Location: Land South and East of The Cathedral Church Of The Holy Spirit, **Stag Hill, The Chase, Guildford, GU2 7UP**

Proposal: Demolition of existing Cathedral Close dwellings and erection of 124 no. residential units (including affordable housing) with associated engineering works, access, landscaping, parking and ancillary works.

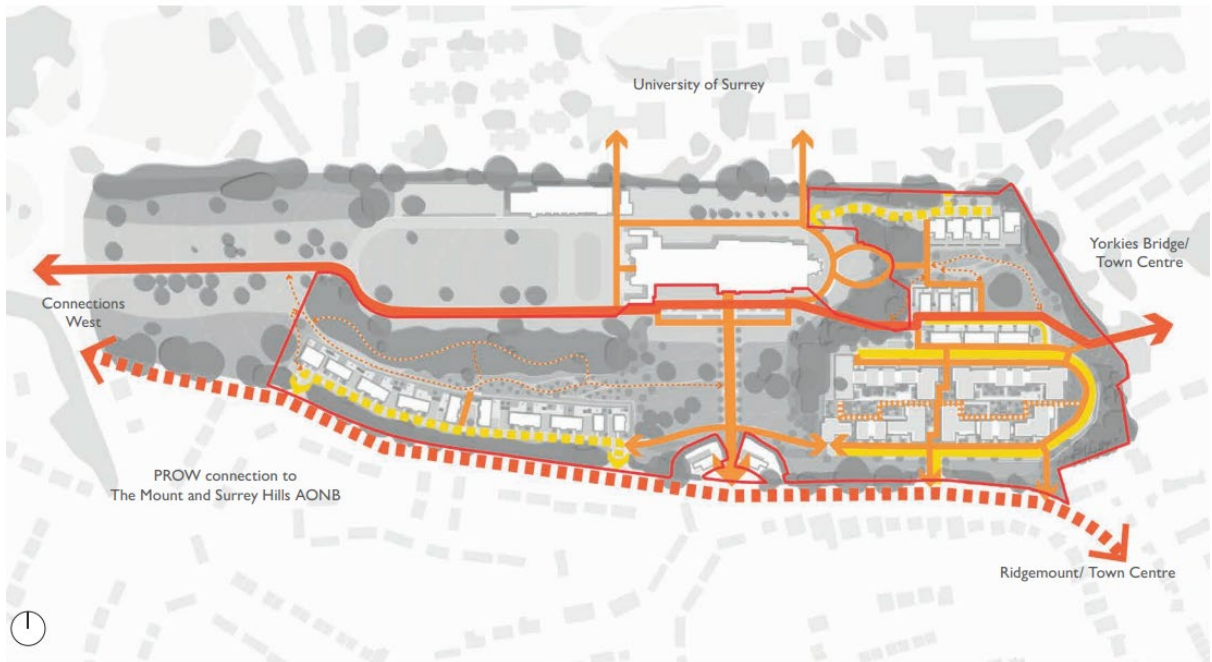
We note that the 'Statement of significance & heritage impact assessment' notes --- *'that it is the open land directly to the west and south of the Cathedral that is vital to protecting its setting as a Grade II* listed building. 4.7 It was these areas, together with a much smaller area directly to the east of the Cathedral, that Maufe eventually intended should be kept free of buildings of any kind'*

The Landscape and visual appraisal appears to be incomplete for an aspect of the scheme that has been identified as important for the setting of a Grade II* listed building.:

- a. Some of the views have a current picture but no after montage or statement that it is not applicable with a reason.
- b. The Visual Appraisal is also limited as it shows all views with foliage on the trees. For the close neighbourhood views, there should illustrations to show the new development with no leaf cover.
- c. There is no statement as to the possible light pollution at night from a development on a highly visible site.
